**RE: APD Crime Paving Improvements
5203 2nd St. NW
Grading and Drainage Plan
Engineer's Stamp Date: 6/7/22
Hydrology File: F15D019A**

Based upon the information provided in your submittal received [xx/xx/xxxx], the Grading & Drainage Plan **is not** approved for Grading Permit. The following comments need to be addressed for approval of the above referenced project:

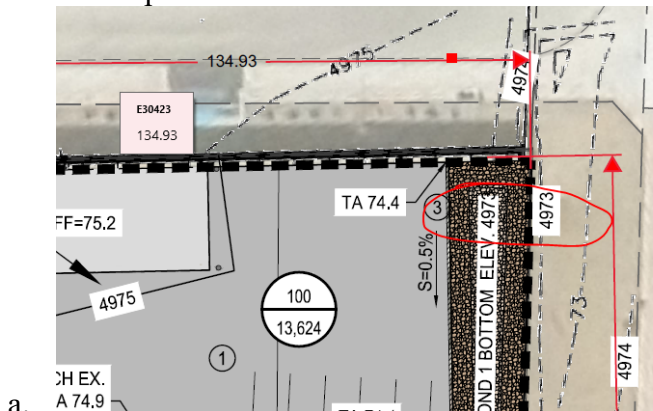
1. Please use a 1:20 scale.
2. Please fade back the existing G&D copied over and make it clear with a note that it is present and is for informational purposes. Perhaps outline or lightly hatch to explain that is existing? I leave that up to you to clearly communicate that it is existing.
3. Please clearly define the basing boundary as the area defined for construction limits of the proposed G&D.
4. Please provide a section of the pond and provide elevations (100 year storm, outlet elevation, SWQV elevation bottom etc...)
5. Please clearly
6. This is unclear (see image below) regarding what elevation this belongs to. Please clarify. Is it the contour? If so, it matches the pond bottom and I cannot tell what the top of pond is and how it spills out.

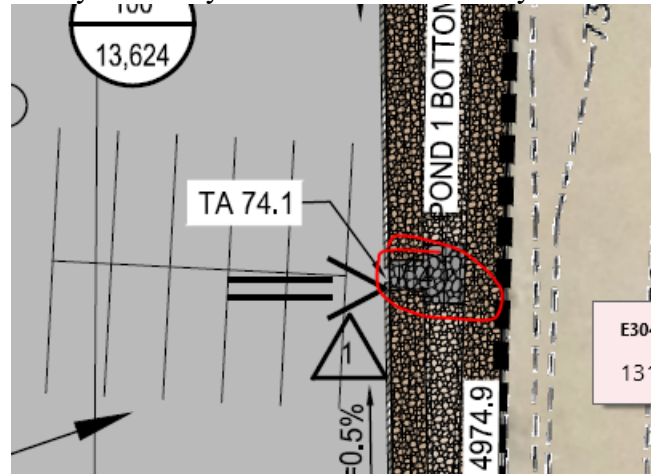
7. Please clearly show keyed note 4. I could barely find it in the plan. See image below.

- a.
 - b. Are there calculations showing the weir opening? Please demonstrate how it will handle the flow going into the pond.
 - c. Provide a detail for construction purposes. It needs inverts at top and bottom as well.
8. Please clearly show a graphic of where the pond will discharge. (overflow)
 9. Will there be a curb and gutter on this parking lot or simply edge of pavement? It is unclear the transition and if there is a flowline to get flow to the rundown.
 10. Please provide benchmark coordinates and tie the construction limits to the benchmark.
 11. Please include datum reference.
 12. Please note this is a retention pond but note where emergency outlet will be.
